Project	IEEE 802.16 Broadband Wireless Access Working Group < http://ieee802.org/16 >	
Title	Comment contribution	
Date Submitted	2002-02-25	
Source(s)	Dave Beyer	Nokia Wireless Routers
	Carl Eklund	Nokia Research Center
	Mika Kasslin	Nokia Research Center
	Nico van Waes	Nokia Wireless Routers
Re:	Ballot 4a	
Abstract	Text corresponding to submitted comments on P80216a/D2	
Purpose	Consideration & decision	
Notice	This document has been prepared to assist IEEE 802.16. It is offered as a basis for discussion and is not binding on the contributing individual(s) or organization(s). The material in this document is subject to change in form and content after further study. The contributor(s) reserve(s) the right to add, amend or withdraw material contained herein.	
Release	The contributor grants a free, irrevocable license to the IEEE to incorporate text contained in this contribution, and any modifications thereof, in the creation of an IEEE Standards publication; to copyright in the IEEE's name any IEEE Standards publication even though it may include portions of this contribution; and at the IEEE's sole discretion to permit others to reproduce in whole or in part the resulting IEEE St

Figure 1—MSH-CSCF schedule example

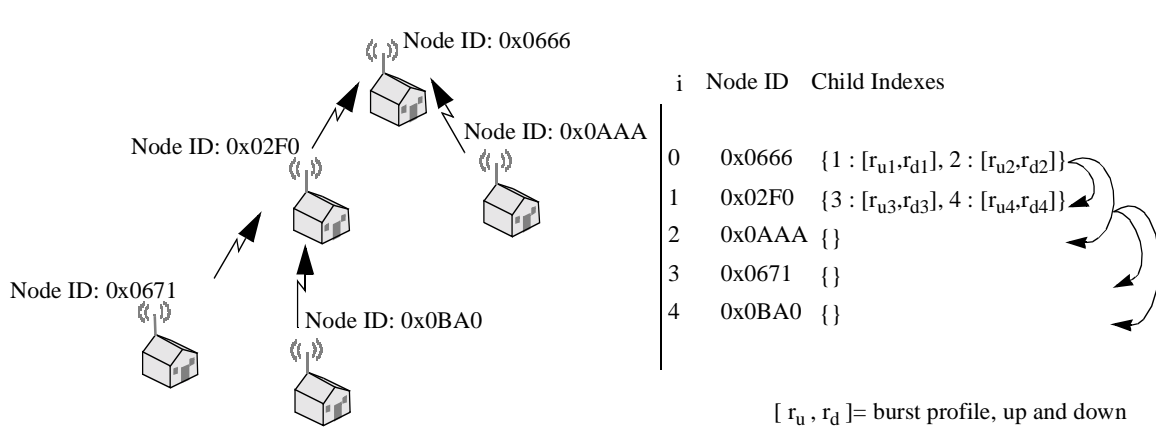
page 56, line 53, add:

A simple example of the use of the centralized scheduling flow-mechanism in MSH-CSCH is provided. For the network shown in Figure 2, the requested flows are shown. The data rate is assumed to be the burst profile number (for simplicity) as shown in Figure 1.

Figure 2—MSH-CSCF flow usage example

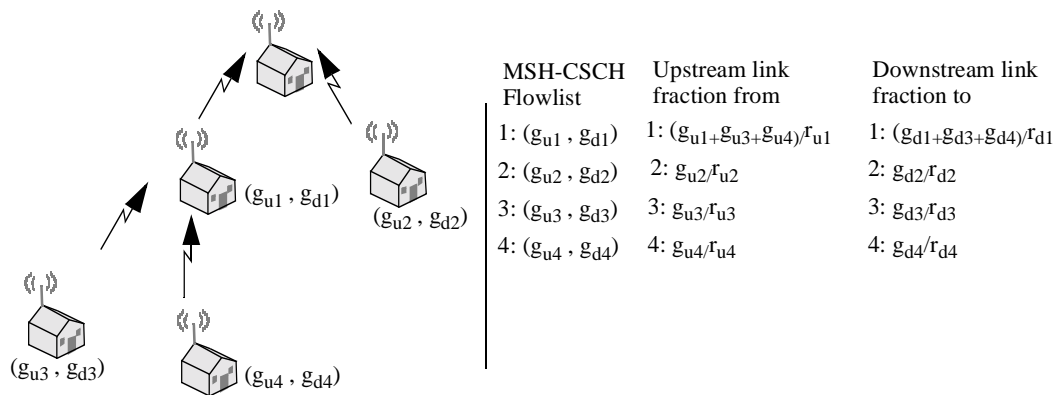
The link fractions shown in Figure 2 are multiplied with $(2^{\text{FlowScale Exponent}+14})$ and with the frame duration, then rounded up to the nearest duration of a whole number of minislots required to transmit this fraction (including preamble).

Each node shall ensure that the duration of all resulting minislot allocations per channel does not exceed the available minislot space (in one or two frames depending on the **Frame schedule flag**) by reducing all allocations proportionally. Each node shall then recursively round down the number of minislots of the allocation with the smallest decimal fraction and add another minislot to the allocation with the largest decimal fraction. Before transmitting the schedule, the mesh BS shall ensure that this computation does not result in non-zero allocations smaller than required to transmit a preamble and one data symbol.

Table 11—Establishing IP Connectivity

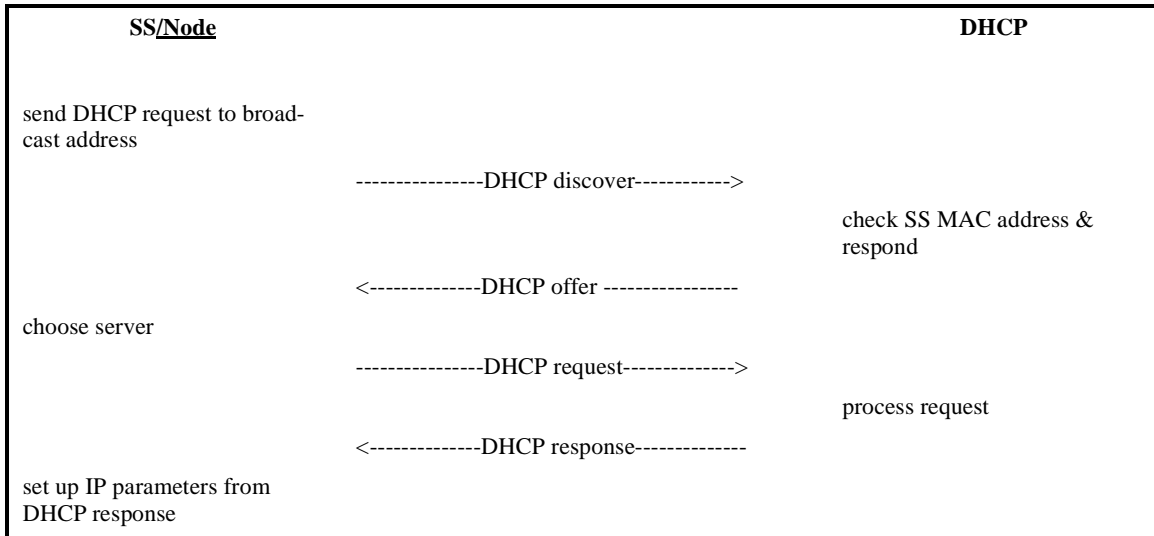
Change Table 62 as shown in Table 11

Figure 231—Channelization, 20 MHz

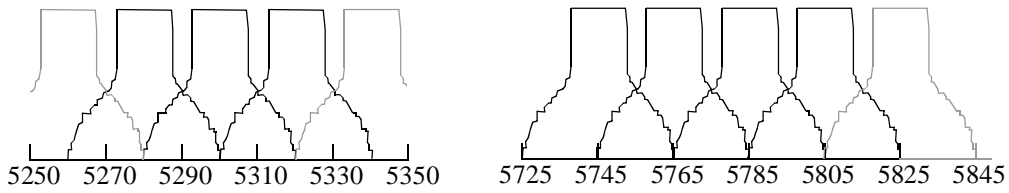
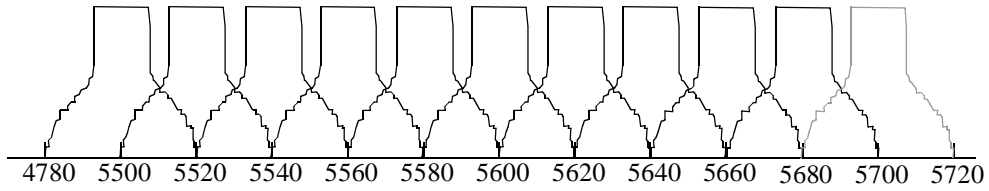
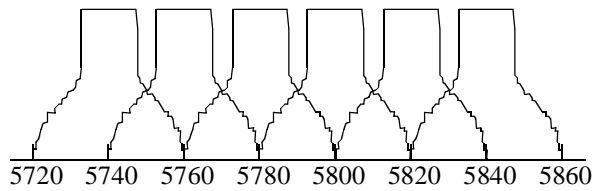
page 188, line 53: Change allocations for CEPT band C (in accordance with RA UK consultation) and renumber

page 189, line 19, replace figure:
